## INDEX

# LIST OF FIGURES

Figure 3.2.3-1 MINIMUM CRITICAL POWER RATIO (MCPR) VERSUS  $\tau$  AT RATED FLOW

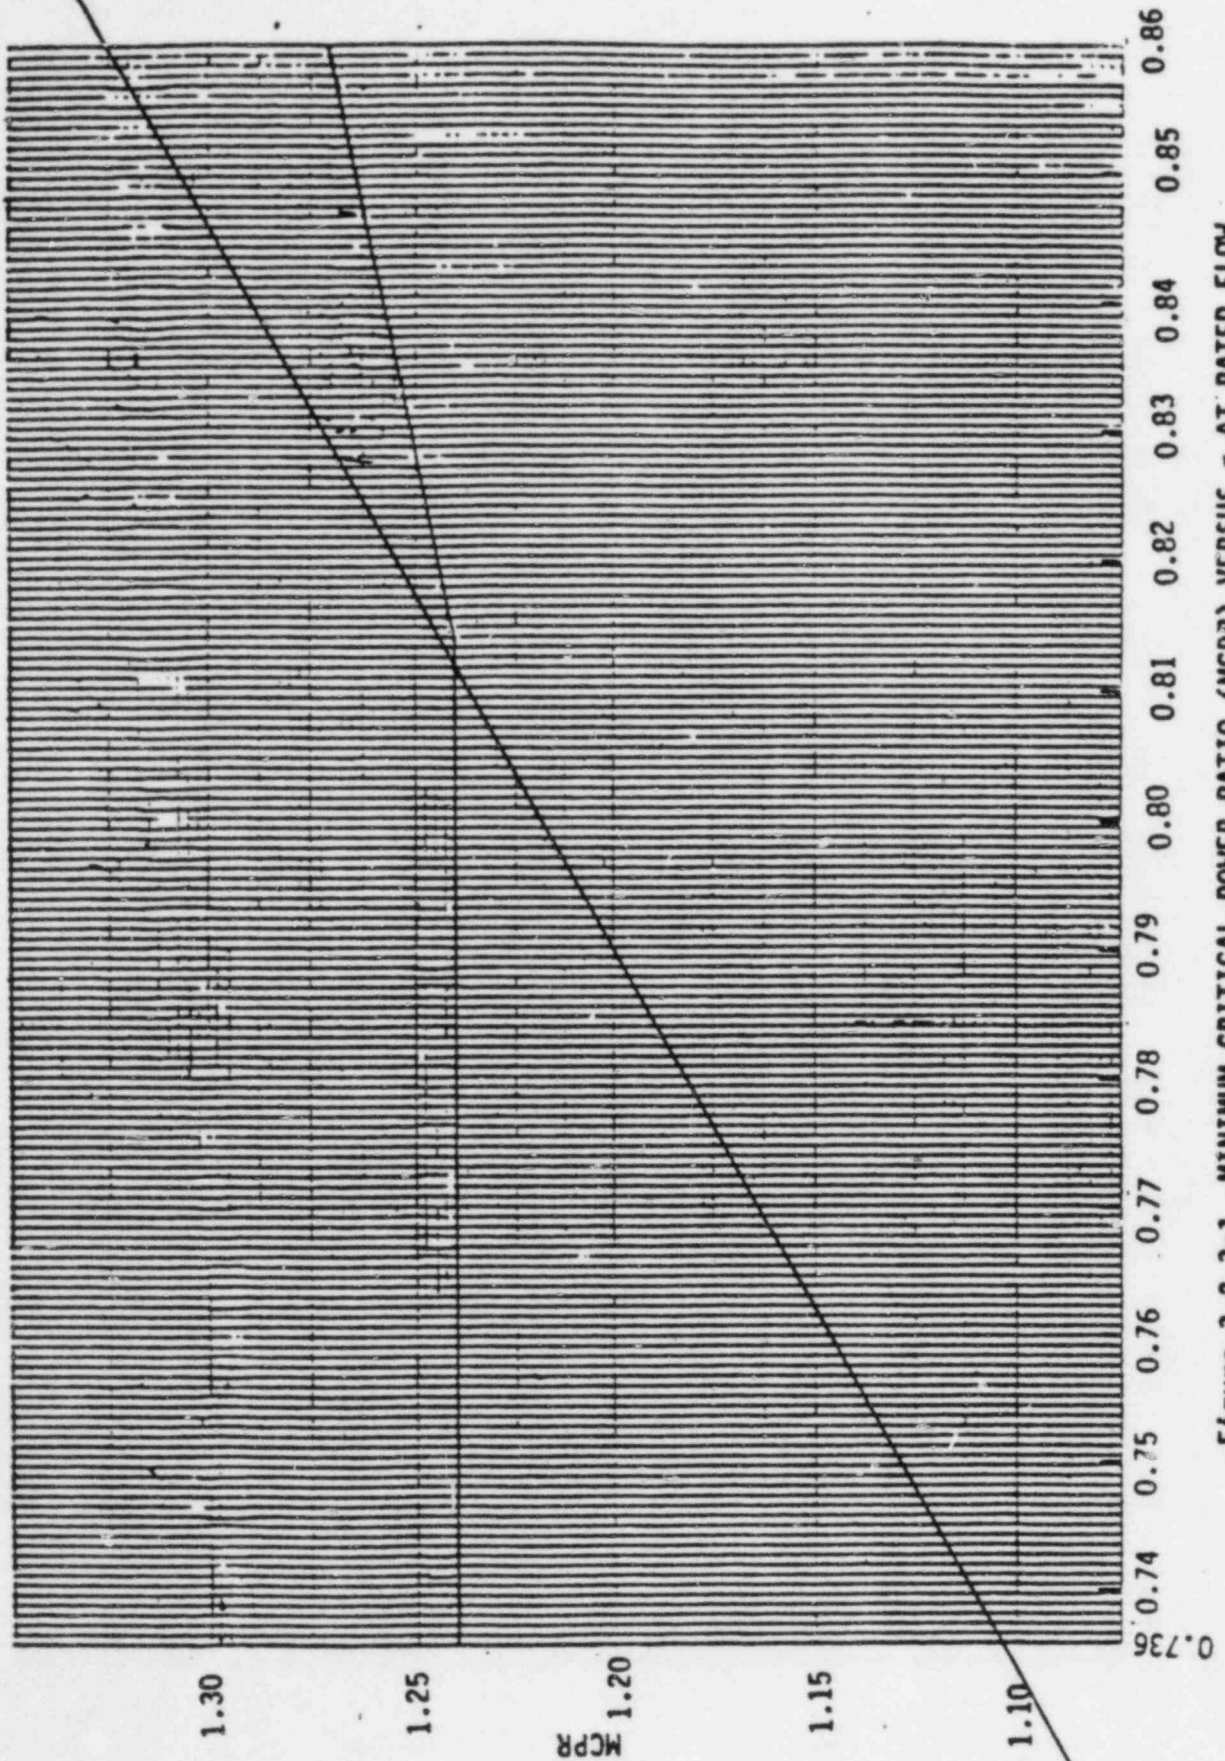
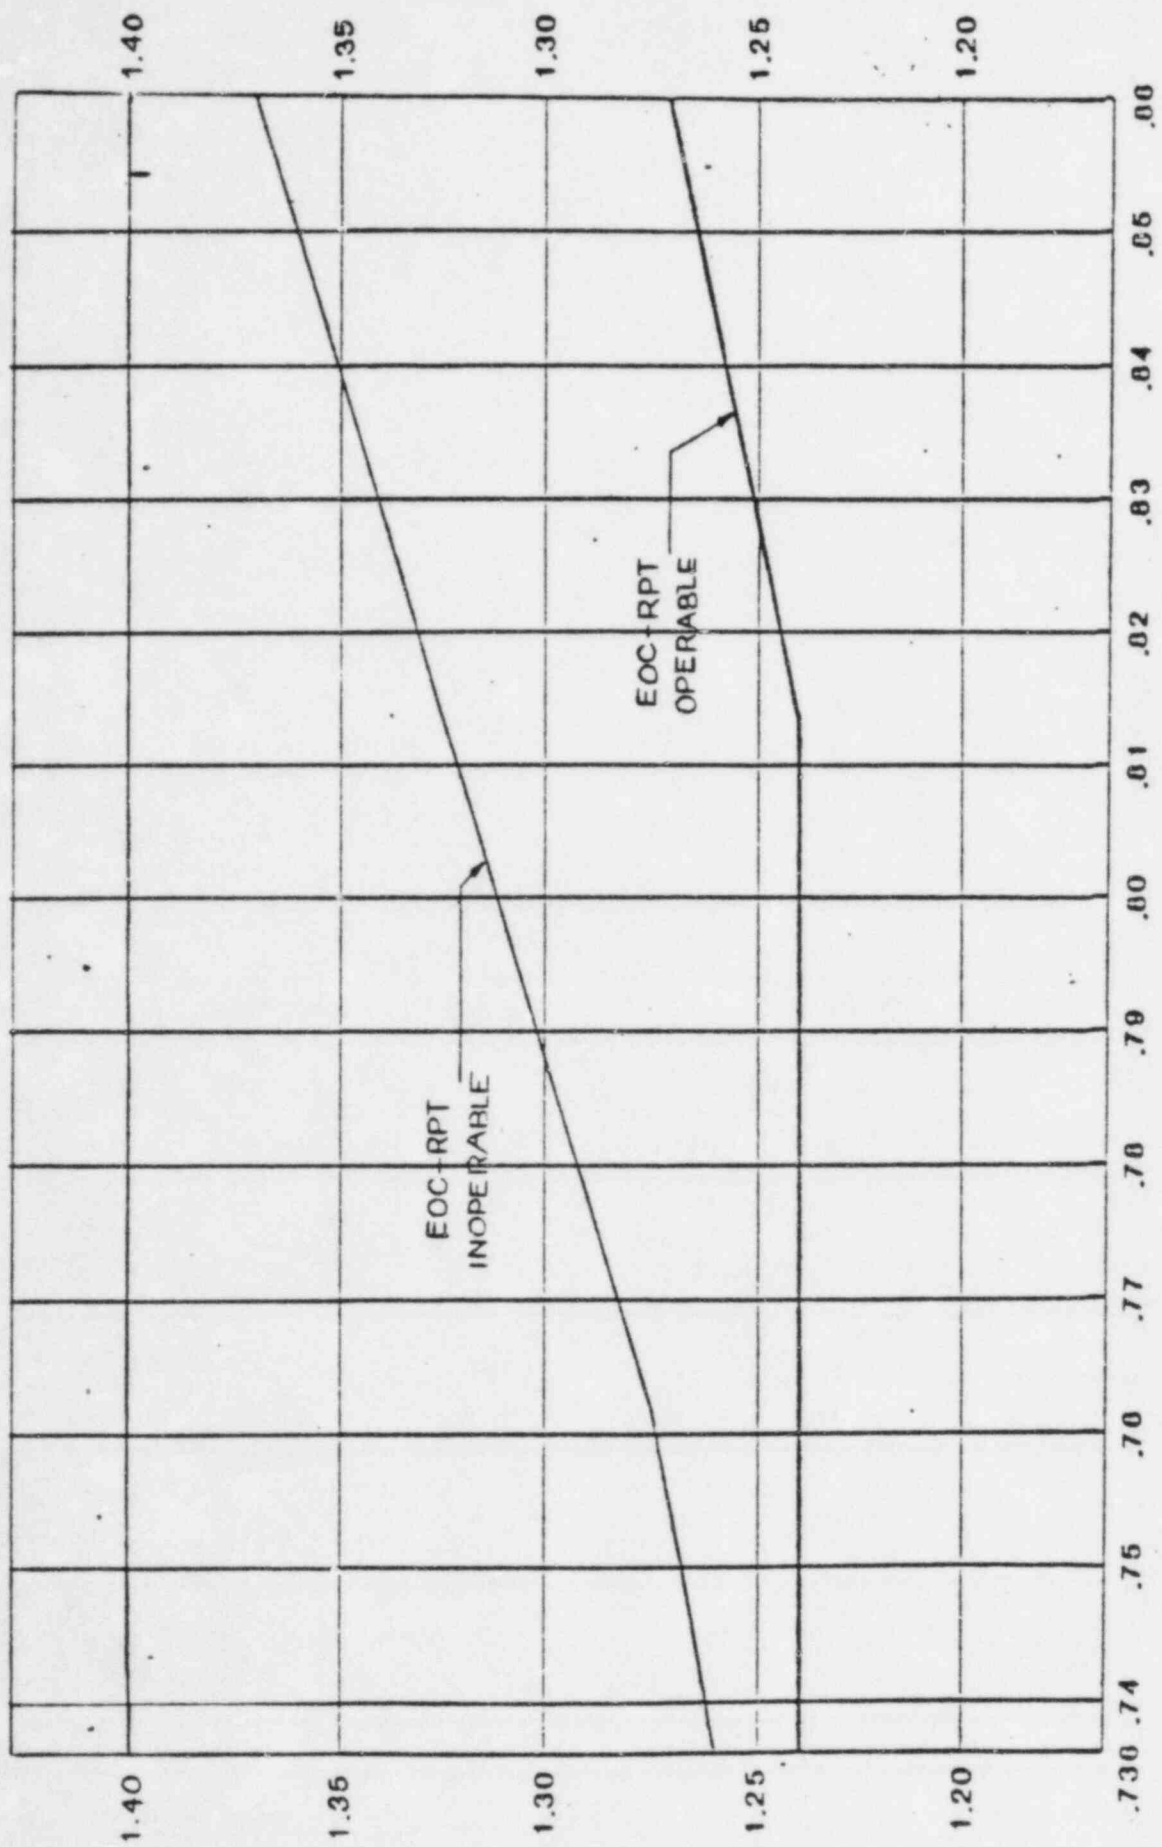
INSERT FOLLOWING PAGE
